ADMINISTRATIVE AMENDMENT

THIS IS THE PREVIOUSLY APPROVED ADMINISTRATIVE DEVELOPMENT ELEVATION AMENDMENT SHEET, WITH THE PROPOSED NEW ADDITIONS HIGHLIGHTED AND ANNOTATED IN RED.

ISOTOPES PARK IMPROVEMENTS • MAJOR LEAGUE BASEBALL
FACILITY UPGRADES RIO GRANDE CREDIT UNION FIELD
SUN AND SHADE ANALYSIS: MAY 21ST, 4:00 PM

COA ISOTOPES PARK
Albuquerque, New Mexico

A5-1

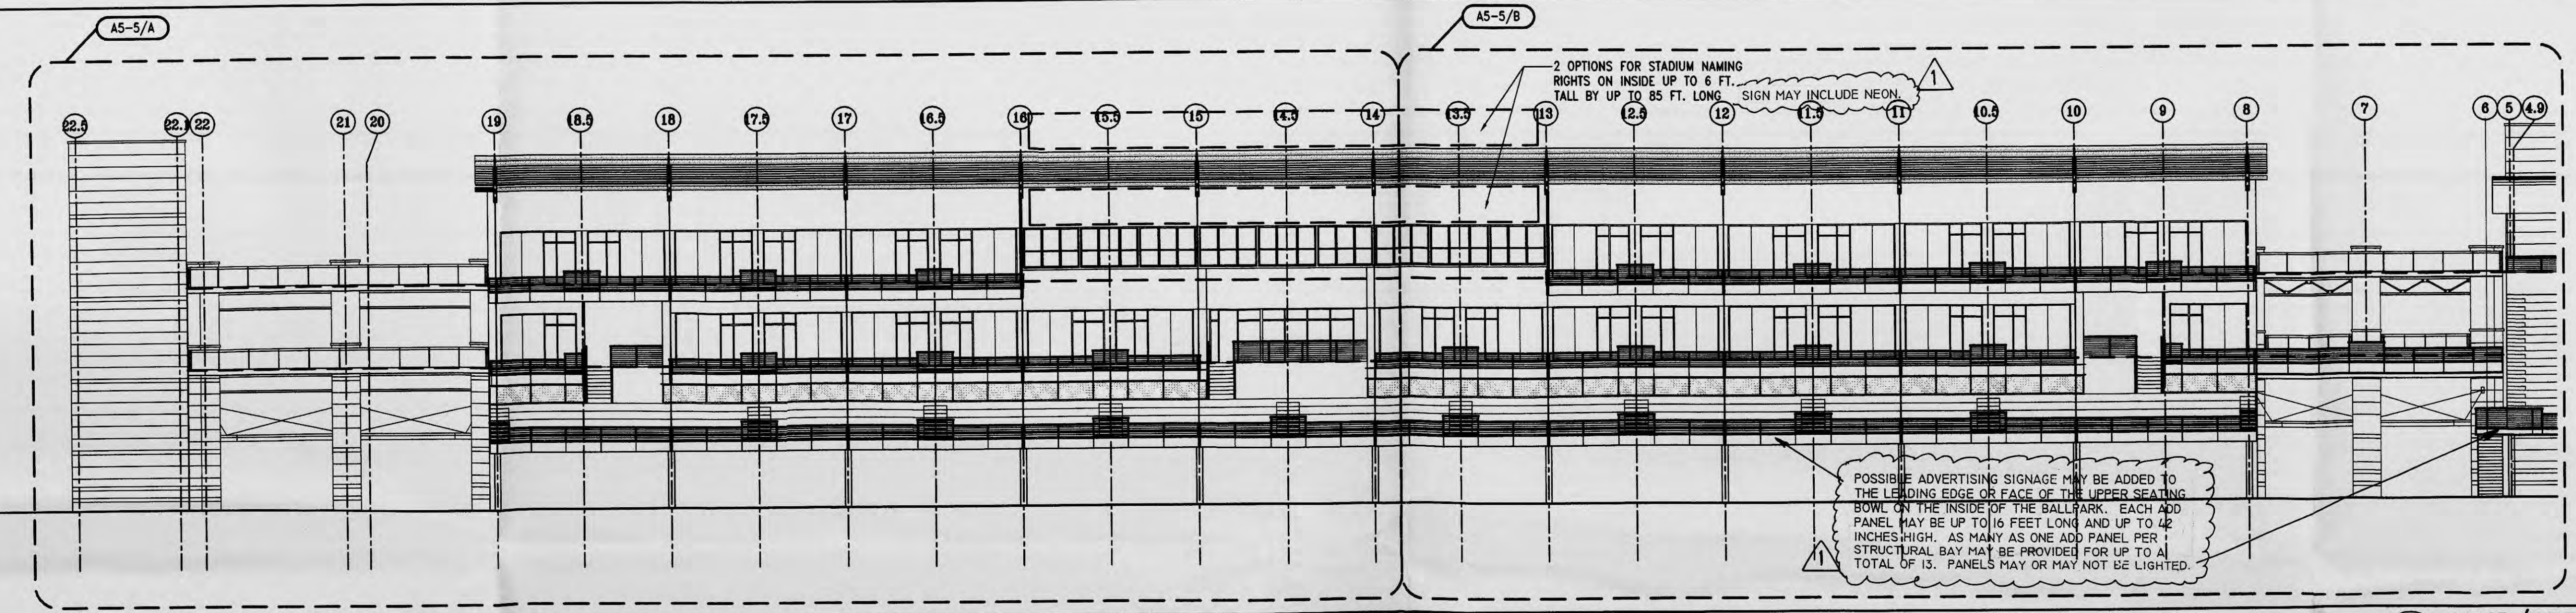
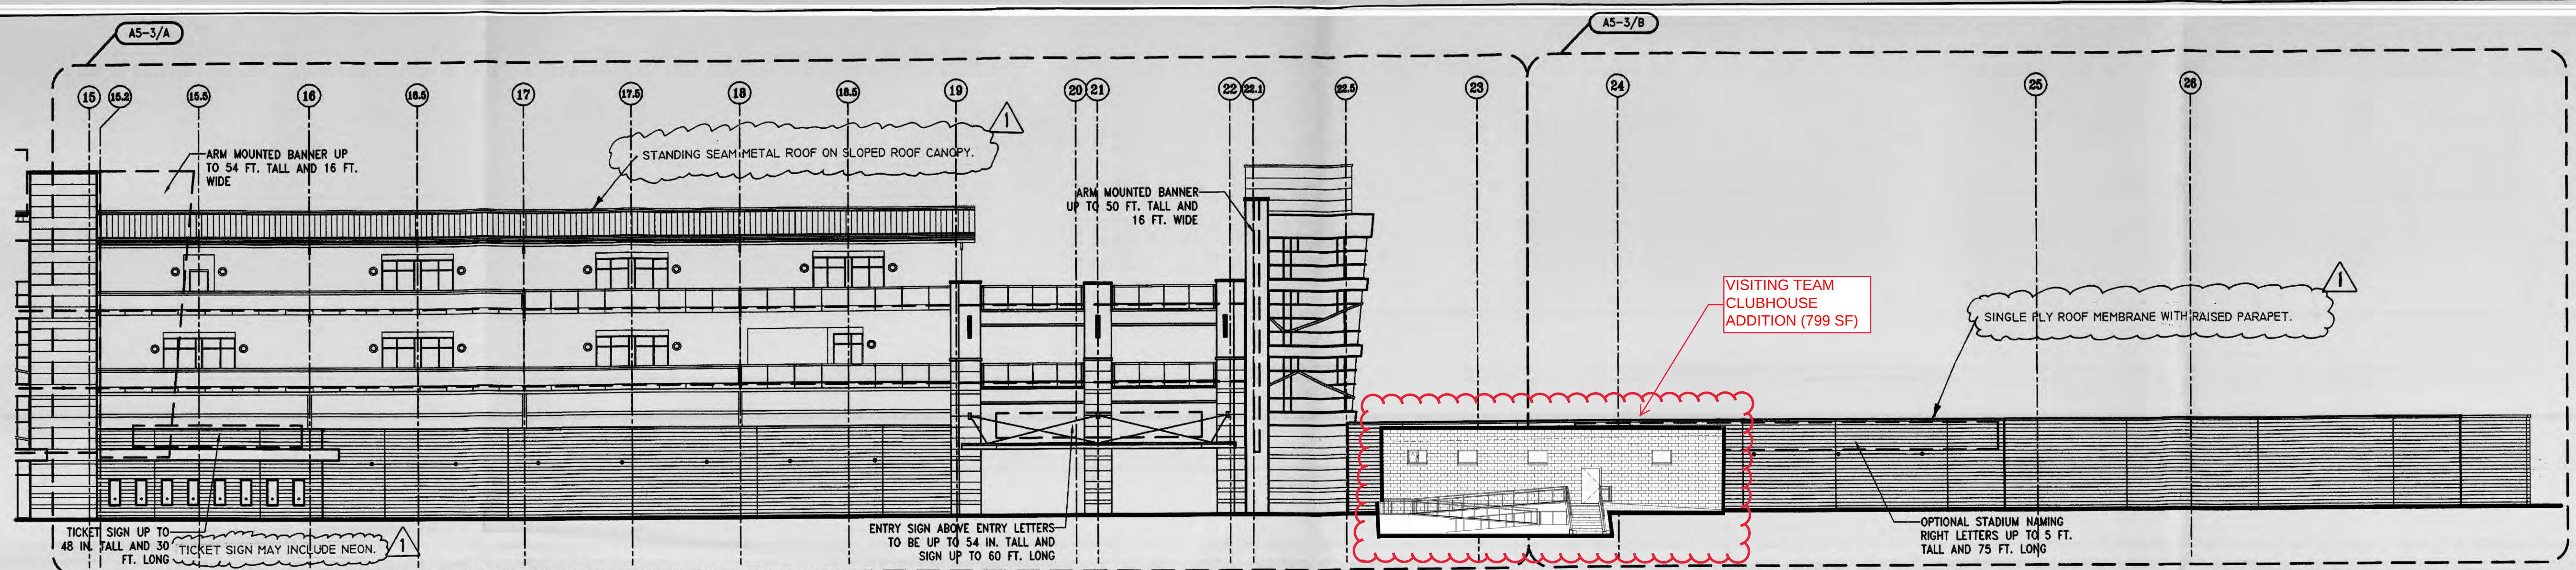
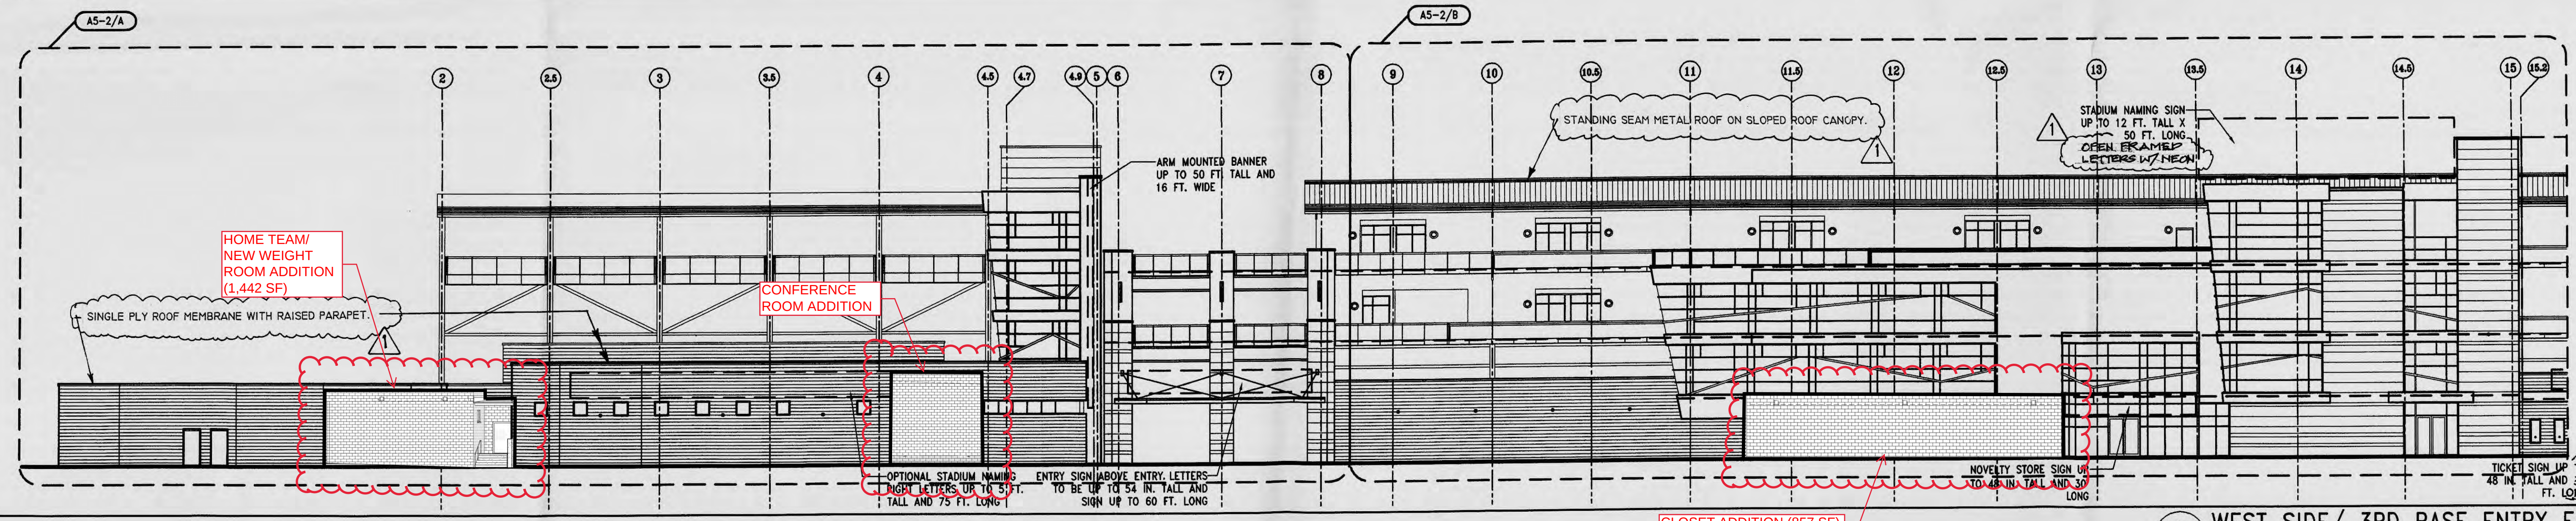
NEW 8 POLE FIELD LIGHTING SYSTEM REPLACING THE EXISTING 9 POLE SYSTEM SHALL UTILIZE 4 EXISTING POLES INCLUDING CATWALKS AND MOUNTING BRACKETS. THE FOUR NEW POLES REPLACE THE OTHER 5 EXISTING POLES. MOST EXISTING LIGHT FIXTURES ARE TO BE REUSED ON BOTH THE NEW AND EXISTING POLES WITH ADDITIONAL NEW FIXTURES ADDED. ALL FIXTURES WILL INCLUDE NEW LAMPS. THE NEW FIELD LIGHTING SYSTEM WILL PROVIDE AVERAGE LIGHT LEVELS OF AROUND 150 FOOT CANDLES FOR THE INFIELD INCLUDING ADJACENT WARNING TRACK, AND AROUND 100 FOOT CANDLES FOR THE OUTFIELD AREAS INCLUDING ADJACENT WARNING TRACK. THE LIGHT POLES WILL BE UP TO 170 FEET TALL IN RELATIONSHIP TO THE PLAYING FIELD ELEVATION. IN ADDITION TO THE LIGHT FIXTURES, SPEAKERS MAY ALSO BE MOUNTED TO THE POLES.
